1. **Addenda:** The following items are to be included and this addendum forms part of the Tender Documents.

DWG. TITLE COMPRESSOR & PROCESS WATER PUMPHOUSE  
Ref. Dwg. 8351-1 A-M3

PROJECT CANADA WINTER GAMES SKI MARTOCK

Scale AS NOTED		
Date APRIL 22, 2009		
Designed BJJ	Drawn By RGH	
Checked	Electronic File 8351 BASE	
Project 8351-1	Dwg SK-A2	Rev 1

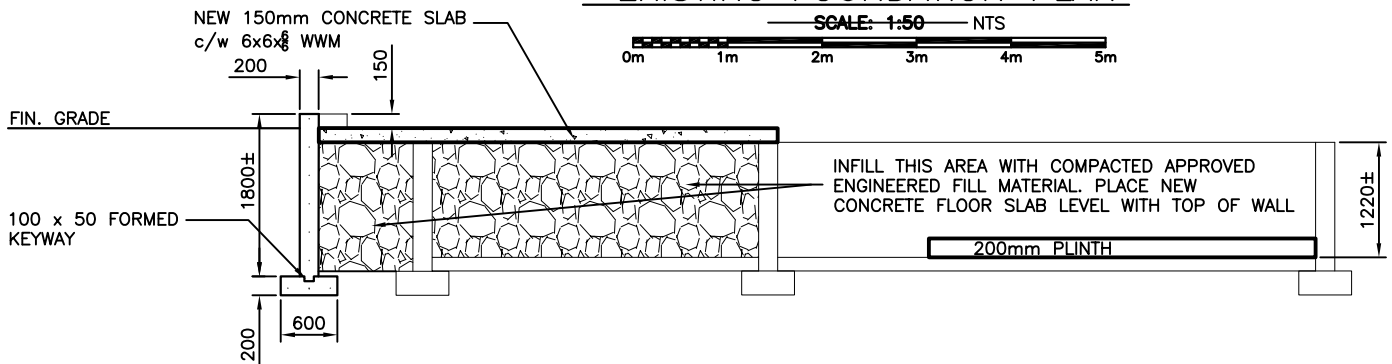
5. To improve surface drainage the new Martock compressor/pumphouse is indicated on attached sketch SK-A2 Rev 1 with a higher floor slab elevation and stepped foundation wall. Drawing M-M2: Supply and install one manual vent at high point and one manual drain at low point, ¾ NPS size, complete with threaded nipples and ball valves.
